RE: ENERGY STAR Luminaires V2.2 Draft Specification Comments

Comments on Draft 1 – Energy Star™ Luminaires v2.2

Section 5.1 – Testing Color Tunable Luminaires

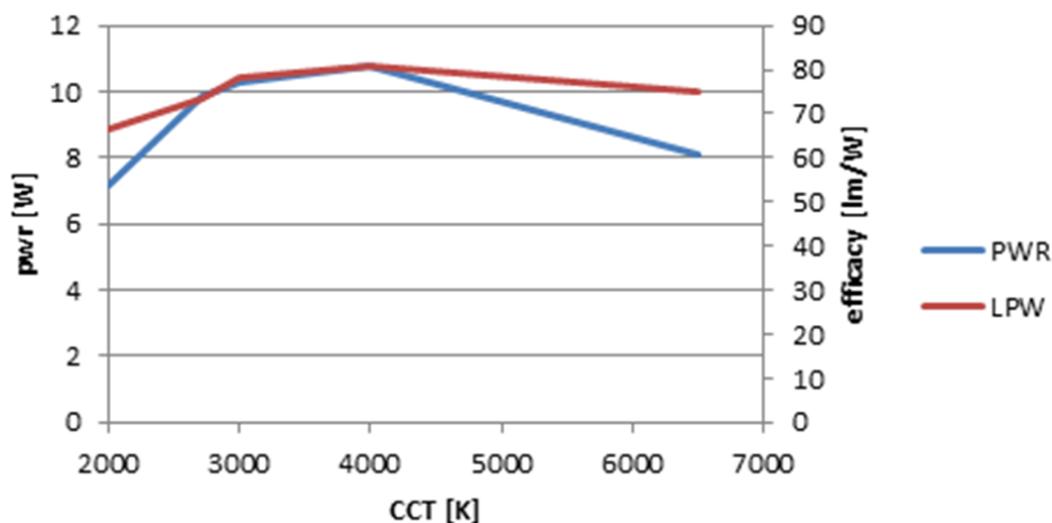
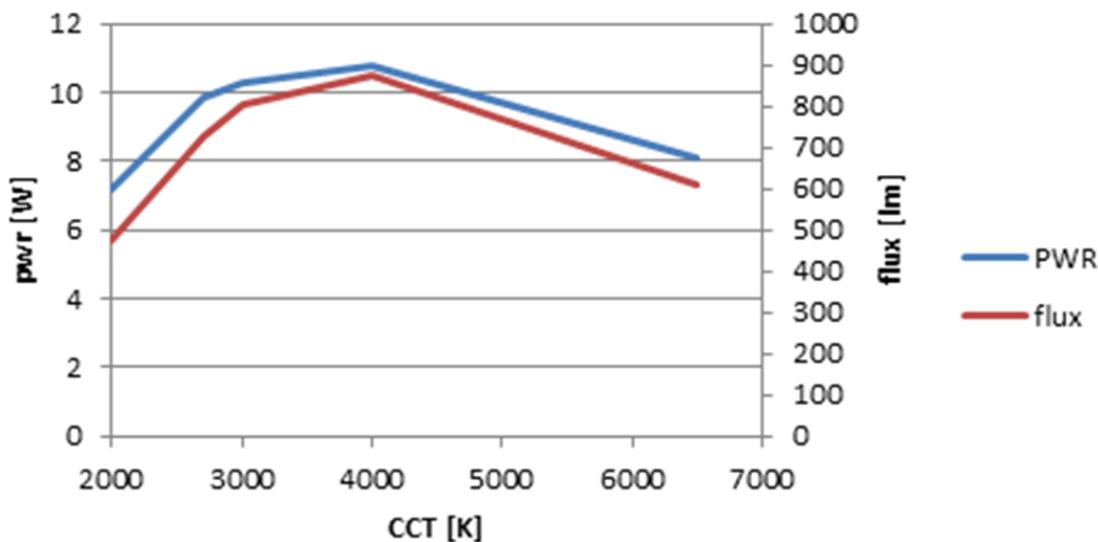
We suggest that Energy Star change the specifications for testing color-tunable luminaires to be consistent with the testing of color-tunable lamps in the Lamps v2.1 specification. We suggest these changes to the bullets in section 5.1:

- All tests and evaluations shall be performed at the ~~Least Efficient~~ **most consumptive** white light setting included in this specification (Section 9.3).
- Additionally, watts, lumens, chromaticity, and CRI shall be tested and reported for Default and Most Consumptive white light settings as applicable (~~if different from least efficient white light setting~~).
